UNITED STATES PATENT AND TRADEMARK OFFICE

APPLICATION NO.	FILING DATE	FIRST NAMED INVENTOR	ATTORNEY DOCKET NO.	CONFIRMATION NO.
10/075,216	02/14/2002	Michael Alois Kolowski	DN2002024	7021

Office Action Summary

FIGURE 4

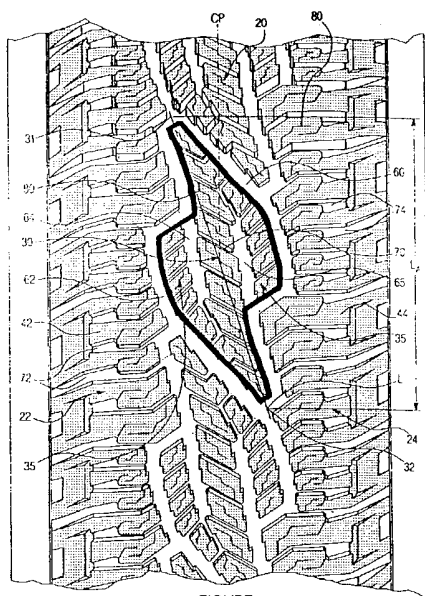
More importantly, the original disclosure fails to teach configuring the array such that it is an "S-shaped" / "substantially S-shaped". The original disclosure describes and illustrates three different arrays. Marked up copies of figures 4, 8, and 12 are provided below:

The markings were added by the examiner to facilitate understanding of the shape of the arrays as originally disclosed. As can be seen from each of figures 4, 8 and 12, none the illustrated arrays have a S-shape. With reference to figure 8, page 11 describes "elongated S shaped". However, this elongated S shape is for narrow groove 76 instead the shape of array 30.

FIGURE 4

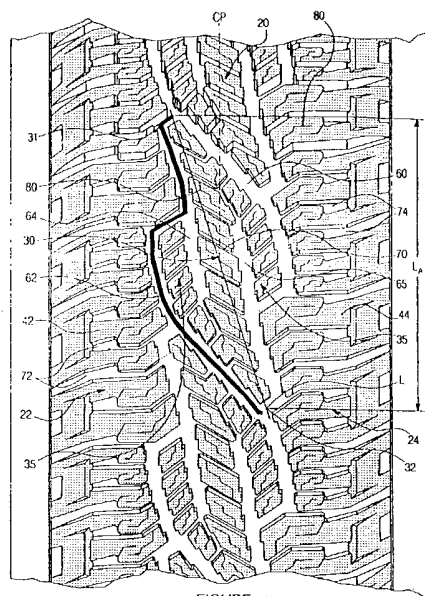
As to claim 15, the subject matter which was not described in the specification in such a way as to reasonably convey to one skilled in the relevant art that the inventor(s), at the time the application was filed, had possession of the claimed invention (i.e. the new matter) is the subject matter of the first and second boundary grooves being "substantially S-shaped" (this expression having no explicit basis in the original disclosure). Although the original disclosure describes groove 76 as being "S-shaped", it does not describe it as being "substantially" S-shaped. More importantly, groove 76 is a groove within an array instead of the boundary grooves defining the array. A marked up copy of figures 4, 8 and 12 is provided below:

The markings, which were added by the examiner, indicate the shape of a boundary groove. As can be seen from the marked up copies, none of the boundary grooves are "S-shaped" or "substantially S-shaped".
